Technical Service Bulletin: tsb101296

Fan Hub Bearing Spacer

Figure 1

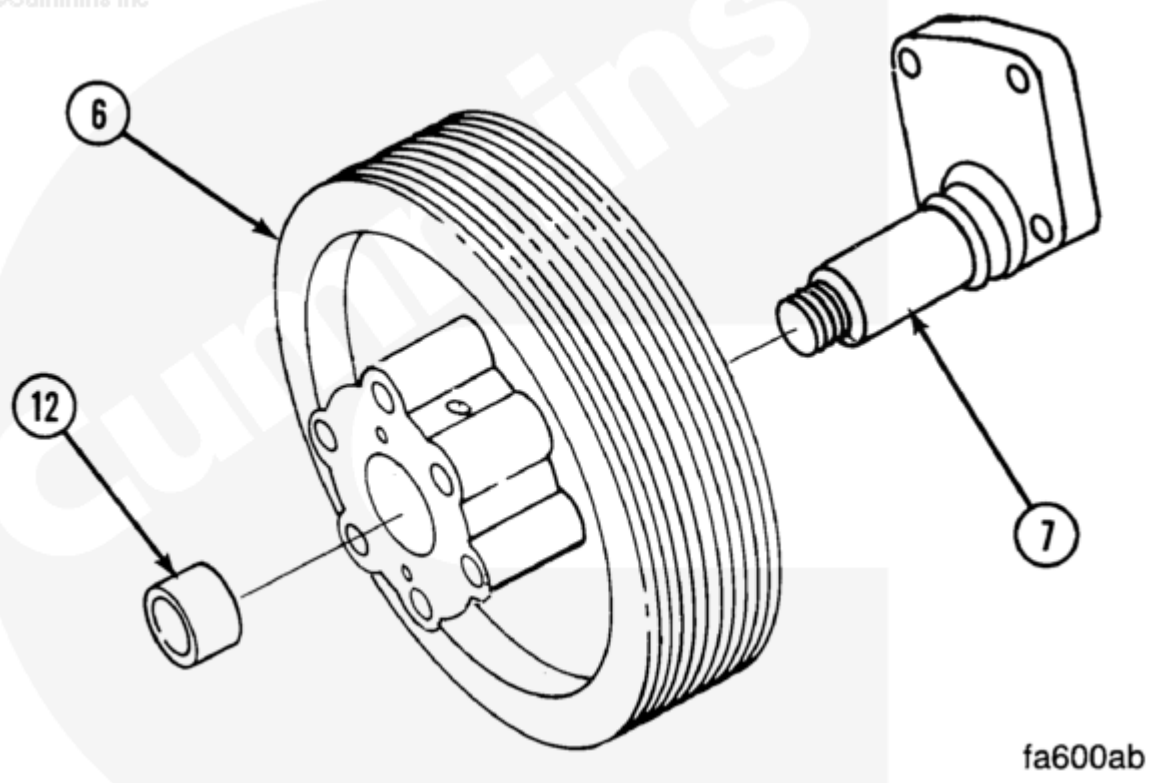
This service/parts topic introduces a new fan hub bearing spacer for the QSK45 and QSK60 engines equipped with a direct drive fan hub. The spacer is located between the two bearings in the fan hub. Its purpose is to maintain preload on the bearings within the fan hub to increase durability.

Previous to the introduction of this spacer, the fan hub for QSK45 and QSK60 engines did **not** contain a spacer. When replacing the bearings or rebuilding the fan hub on engines built prior to the introduction of the fan hub bearing spacer, install the new spacer to the fan hub.

The spacer is denoted by arrow 12 in Figure 1 below.

The new spacer, Part Number 4100760, was introduced in production at Daventry with engine serial number first 33152994 on 19-August-2002 and is compatible with all QSK45 and QSK60 engines fitted with the direct drive fan hub.
